Subject: CTO-0128: Response to Regulatory Comments on the Revised Draft Engineering Evaluation/Cost Analysis for IRP Site 1, Inactive Landfill, Former Naval Training Center, Proposed Grading Plan, Port of San Diego, Northern Portion of Landfill and Conceptual Models for Consolidation Alternatives, IRP Site 1

**RESPONSE TO REGULATORY COMMENTS ON THE REVISED DRAFT ENGINEERING EVALUATION/COST ANALYSIS  
(EE/CA) FOR INSTALLATION RESTORATION PROGRAM (IRP) SITE 1, INACTIVE LANDFILL,  
FORMER NAVAL TRAINING CENTER, SAN DIEGO  
CTO-0128**

**CTO-128 Former Naval Training Center, San Diego**  
**IR Site 1, Inactive Landfill**  
Removal Action Alternative  
Assumptions for Conceptual Models 1, 2, and 3  
October 14, 1999

### **CONCEPTUAL MODEL 3 (Figure 3)**

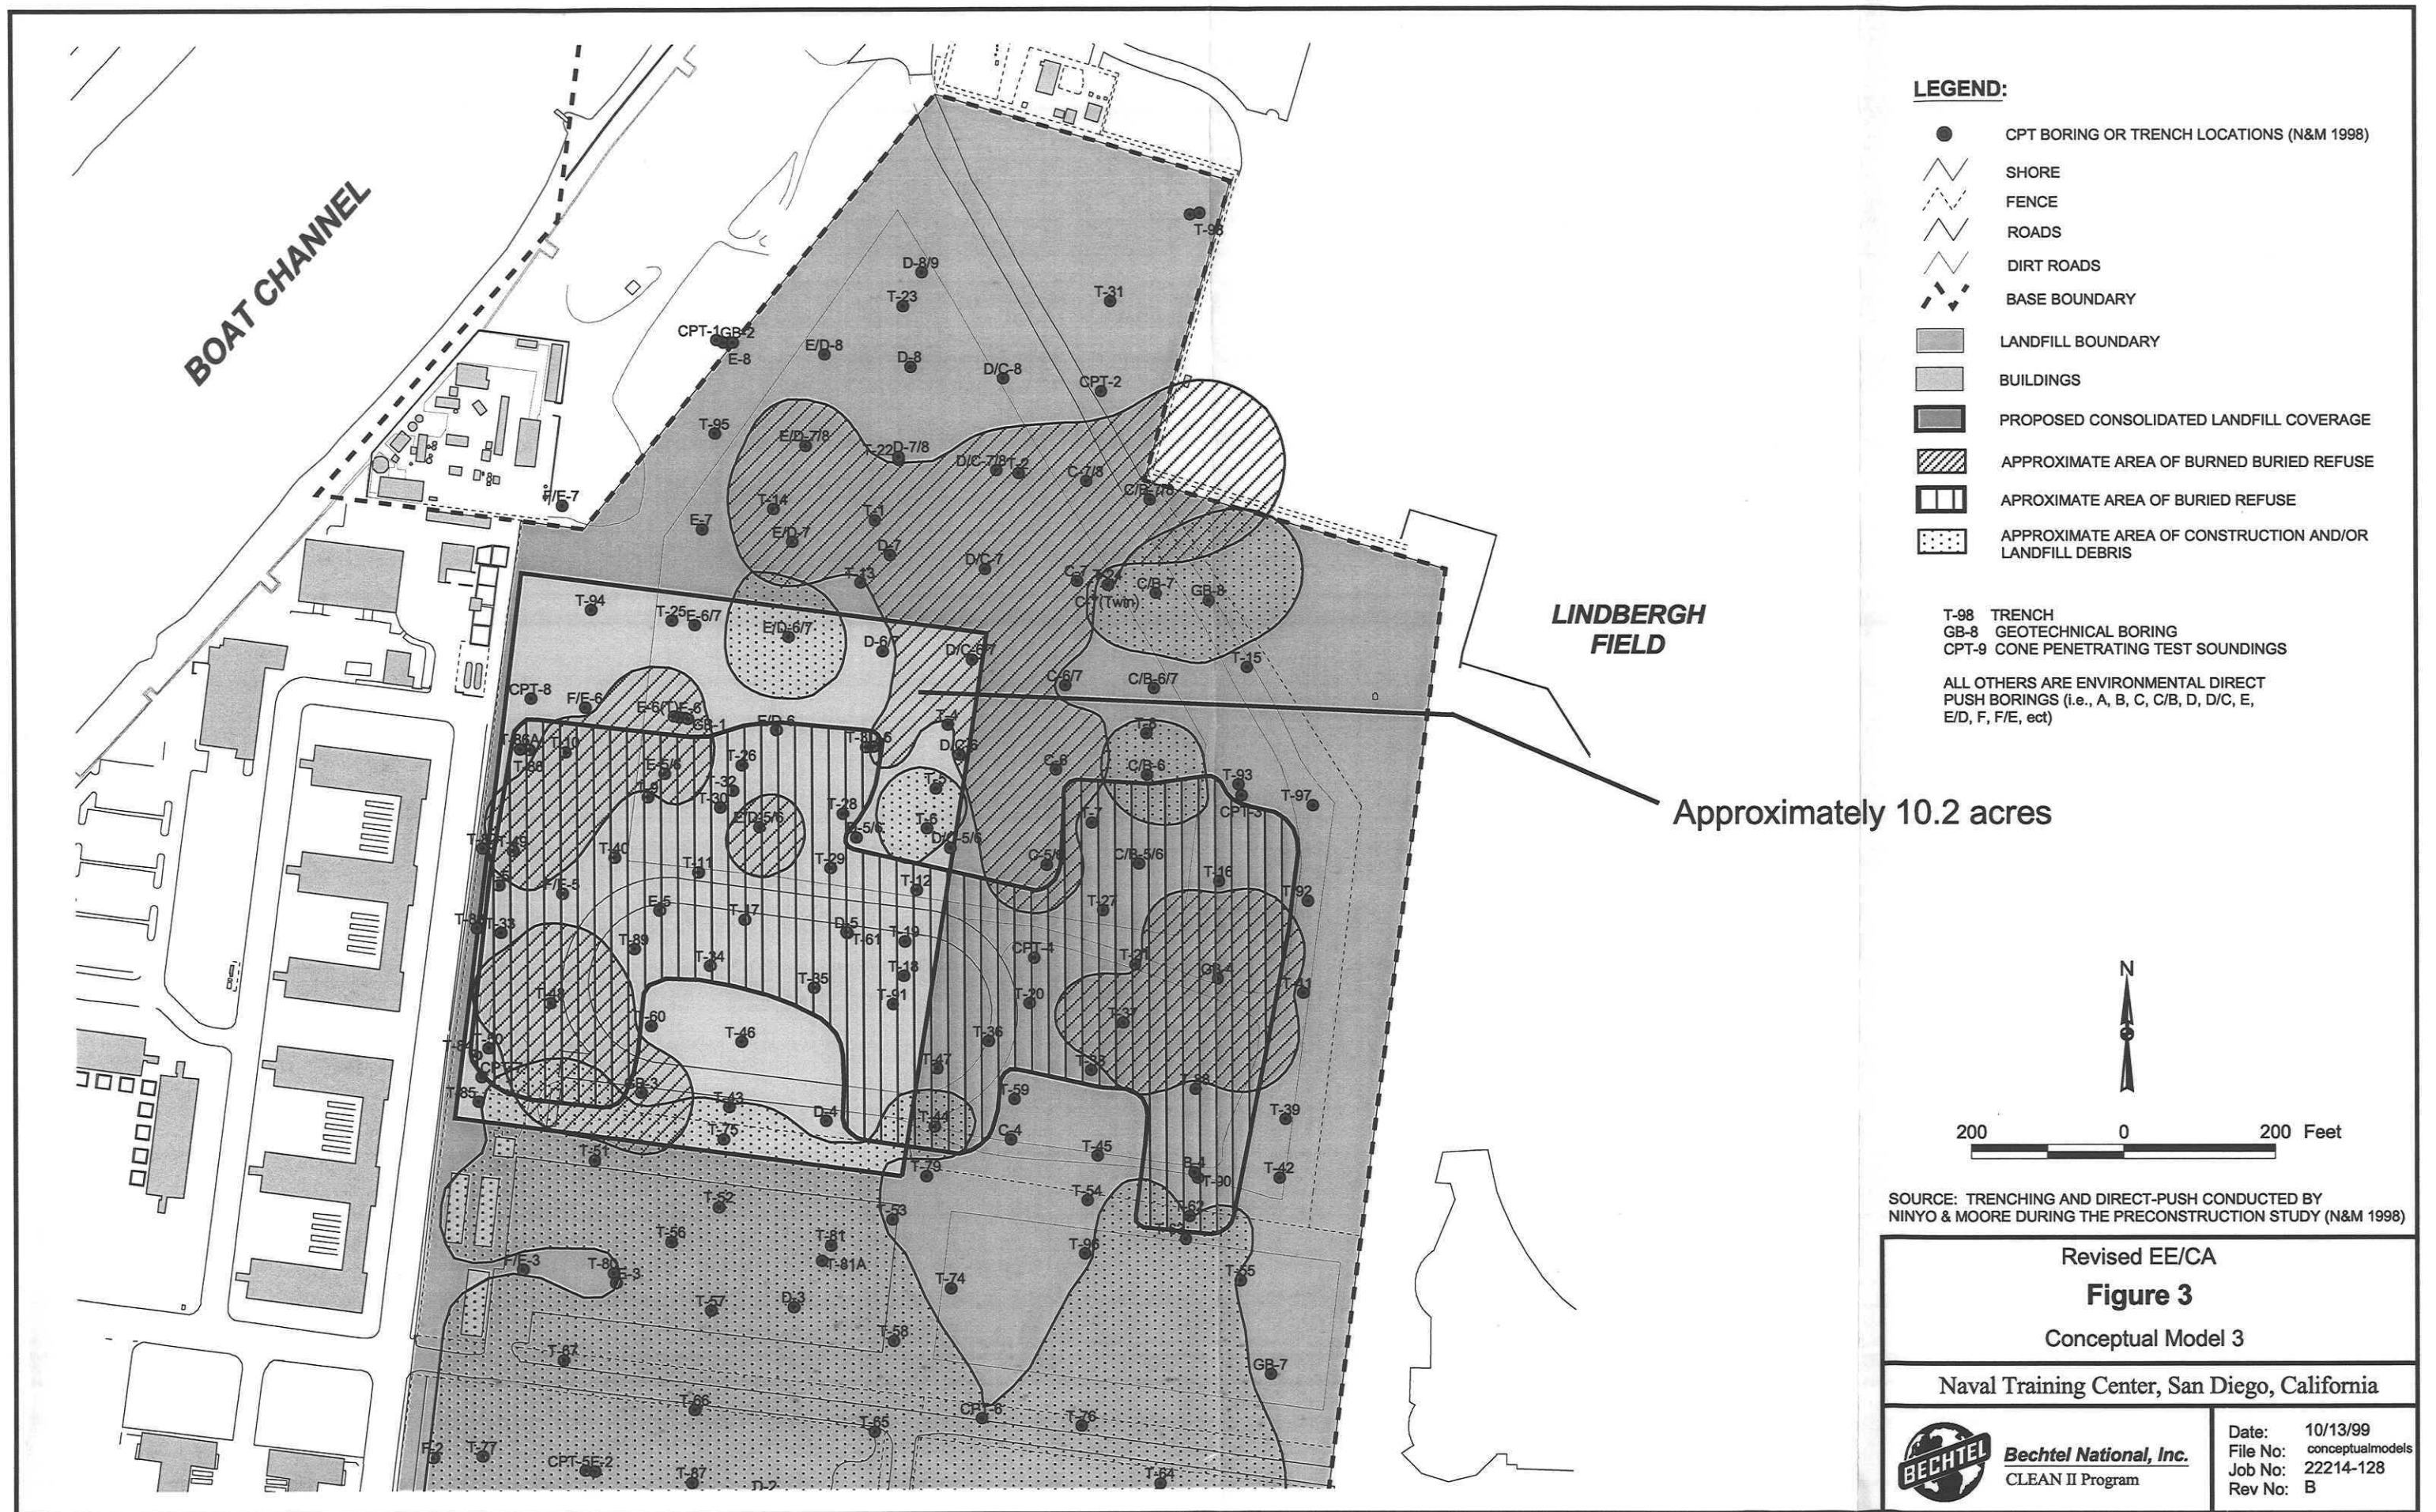
- Size: 740 feet by 600 feet (approximately 10.2 acres)
- Calculated minimum slope: 3% (both ways)
- Minimum height requirement: 9 feet (includes a minimum 2 foot final cover)
- Approximately 43,000\* cubic yards of waste to be consolidated
- This model provides adequate room to accommodate all waste.
